9.1 NO. 128A (LOT: 2; STR: 80812) HAROLD STREET, MOUNT LAWLEY - PROPOSED ALTERATIONS AND ADDITIONS TO GROUPED DWELLING

PURPOSE OF REPORT:

To consider an application for development approval for alterations and additions to an existing grouped dwelling at No. 128A Harold Street, Mount Lawley (the subject site).

WEST ELEVATION
1:50

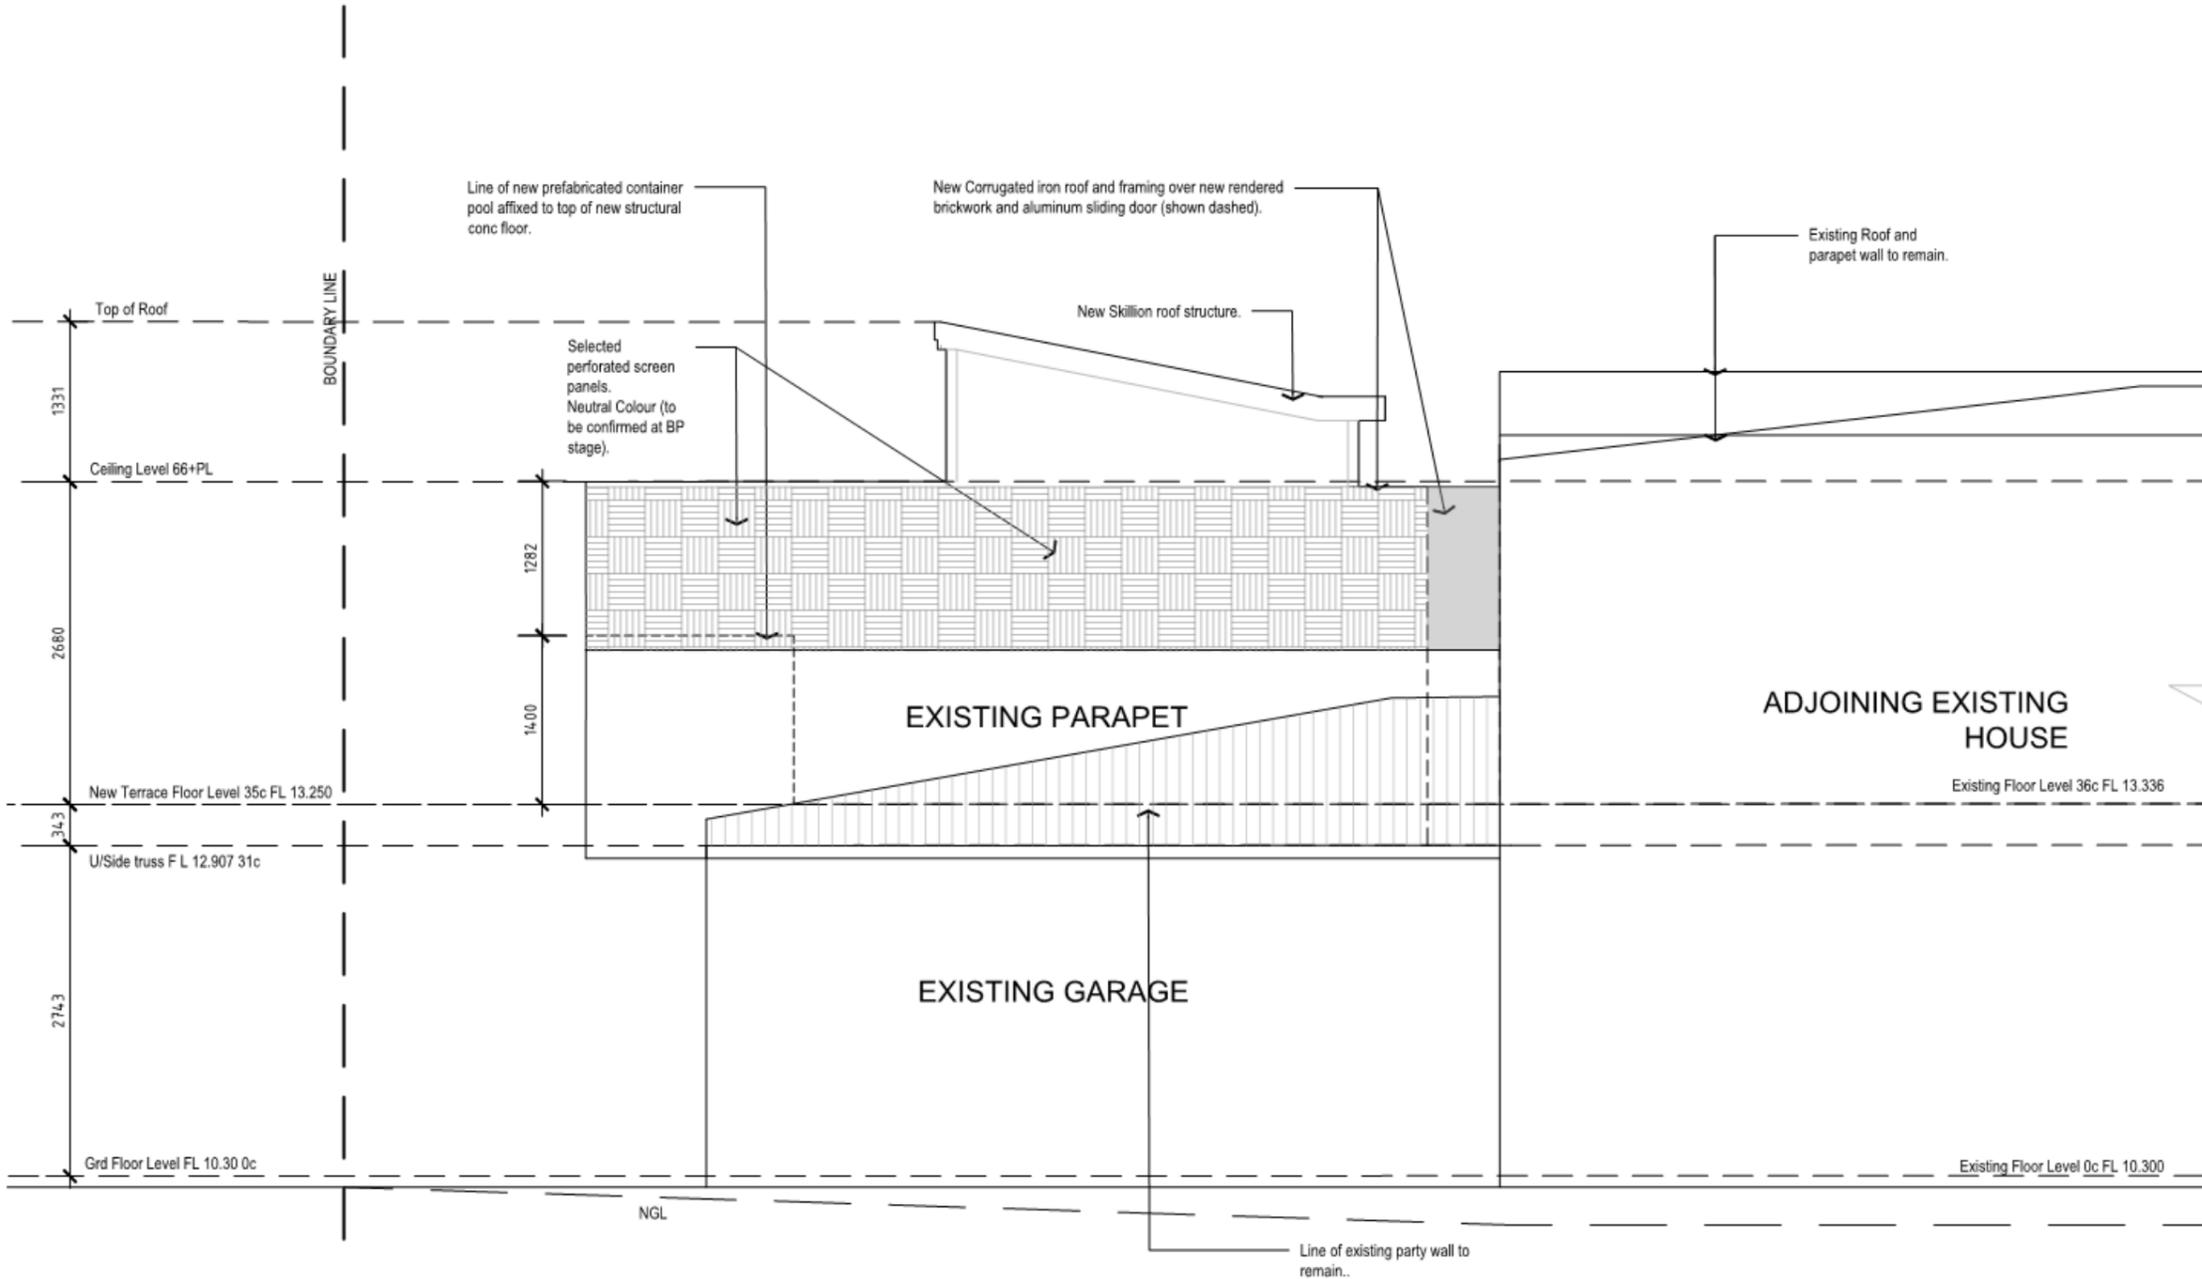
The privacy screen proposed to the north west of the first floor terrace is 7.6 metres in length and 1.3 metres in height and would be on top of an existing parapet wall. The proposed privacy screen to the first floor terrace would extend the existing boundary wall along the north western lot boundary by 7.6 metres to a total boundary wall length of 31.3 metres. The proposed privacy screen would also result in a 1.3 metre increase to the existing boundary wall height for this portion of the boundary to a height of 6.1 metres.

- The proposed increase of 1.3 metres in height of the existing boundary wall would be due to the installation of aluminium privacy screening. The screen would be of varying material and colour to the existing parapet wall that would assist with breaking up the mass, reducing the appearance of blank walls and creating visual interest.
